**FEMA Levee Certification  
Ventura County, California**

**Calleguas Creek Levee and Somis Drain Floodwall (CC-2)  
Mission Oaks Boulevard to Adolfo Road**

**Evaluation Report**

Calleguas Creek Levee (CC-2) (Photo No. P1) – 48” RCP with a flap gate

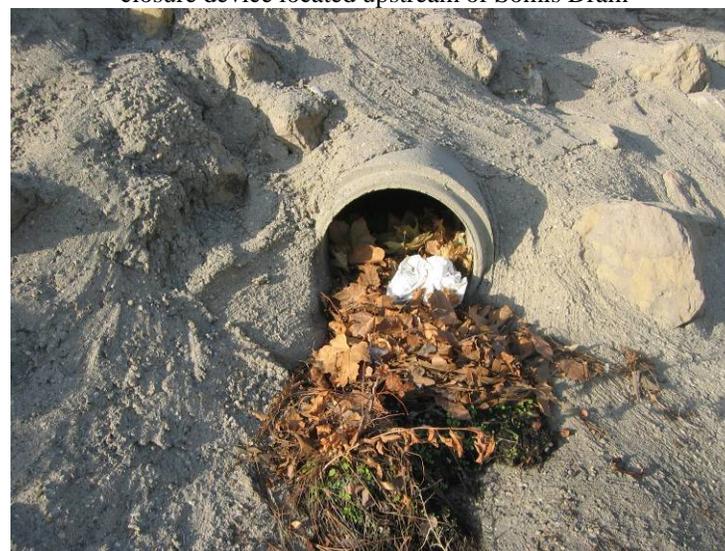
River* Station	GPS		**Photo No.	Description
	Lat	Long		
<i>Calleguas Creek Levee (CC-2) – Along Calleguas Creek Levee</i>				
14+85	N34.21666	W119.01558	P1	48” RCP with a flap gate
18+00	N34.22275	W119.01659	P2	Somis Drain confluence with Calleguas Creek
7+55	N34.22325	W119.01610	P3	10” steel pipe w/o a closure device located upstream of Somis Drain
14+10	N34.22484	W119.01560	P4	18” RCP w/o a closure device located upstream of Somis Drain. (Not shown on as-built plan.)
<i>Calleguas Creek Levee (CC-2) – Somis Drain</i>				
87	N34.22278	W119.02223	P5	18” RCP with a flap gate near Flynn Street Bridge. (Not shown on as-built plan.)

**Calleguas Creek Levee (CC-2)** (Photo No. M12) – A flap gate for 18” RCP is fixed open by debris. (Riverward side)

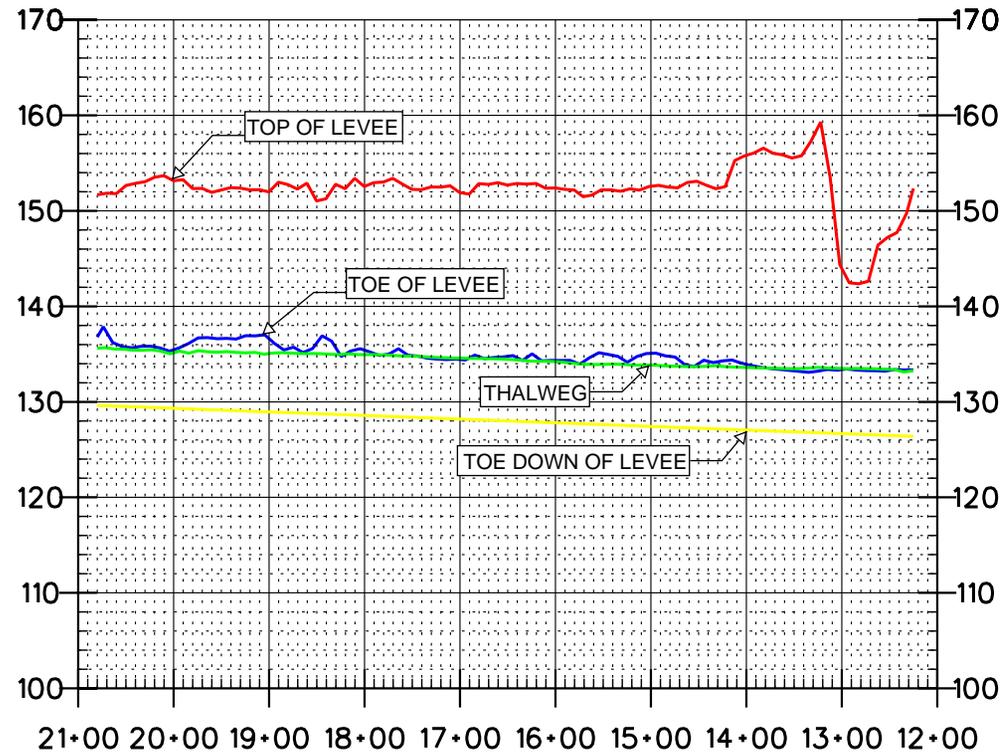
GPS		*Photo No.	Description	Action Required
Lat	Long			
<i>Calleguas Creek Levee (CC-2) – Somis Drain</i>				
N34.22287 to N34.22275	W119.01660 to W119.02259	M11	Vegetation (Landscaping) within 15' of floodwall for its entire length (Landward side)	Vegetation may need to be removed. In which case, remove vegetation and root ball, fill voids with impervious material and firmly compact.
N34.22278	W119.02223	M12	A flap gate for 18" RCP is fixed open by debris. (Riverward side)	Remove debris from pipe opening and ensure complete seal around the gate.

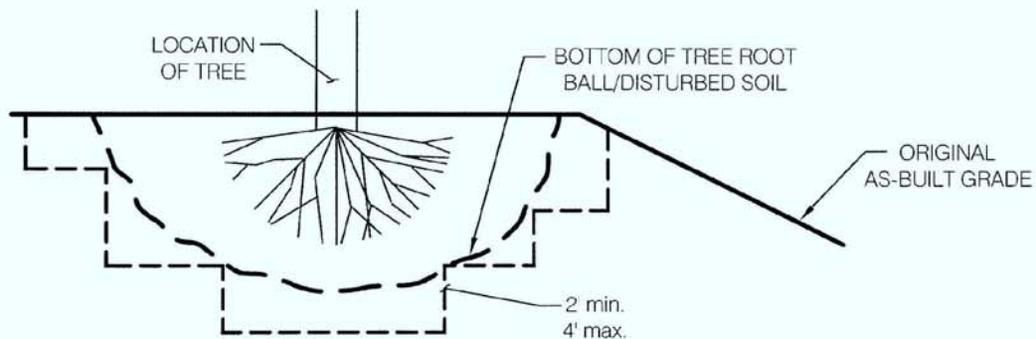
<p>4. Can Tetra Tech provide specs for compaction and grading requirements? Discuss major and minor repair examples.</p>	<p>Compaction requirements are detailed on the attached Figures 1 and 2. Major repair examples include any erosion feature that is deeper than 1 foot or that is greater than 2 feet wide. Major and minor animal burrows are discussed in item 1.</p>
<p>5. Can in-kind materials be used for backfill?</p>	<p>In-kind backfill would be materials free of organic or deleterious debris that has similar or lower permeability than the levee material. These materials could consist of excavated soil, imported soil, concrete, or slurry, and shall be evaluated by the testing and materials lab.</p>
<p>6. Discuss documentation/inspection requirements for verification of grading.</p>	<p>The requirements for verification of grading are discussed above.</p>

1. REMOVE ALL DISTURBED MATERIAL AND BENCH VERTICALLY INTO COMPETENT MATERIAL.
2. RESTORE TO ORIGINAL GRADE BY PLACEMENT OF APPROVED EXCAVATED SOIL OR IMPORTED SOIL WITH EQUIVALENT OR LOWER PERMEABILITY.
3. PLACE MATERIAL IN HORIZONTAL LIFTS (12 INCH MAXIMUM THICKNESS), MOISTURE CONDITIONED TO AT LEAST OPTIMUM MOISTURE CONTENT AND COMPACTED TO AT LEAST 90 PERCENT OF MAXIMUM DRY DENSITY PER ASTM D1557.
4. COMPACTION TESTING SHOULD BE PERFORMED PER ASTM D1556 OR D2922, A MINIMUM OF 1 TEST PER 3 CU. YD. OF BACKFILL.
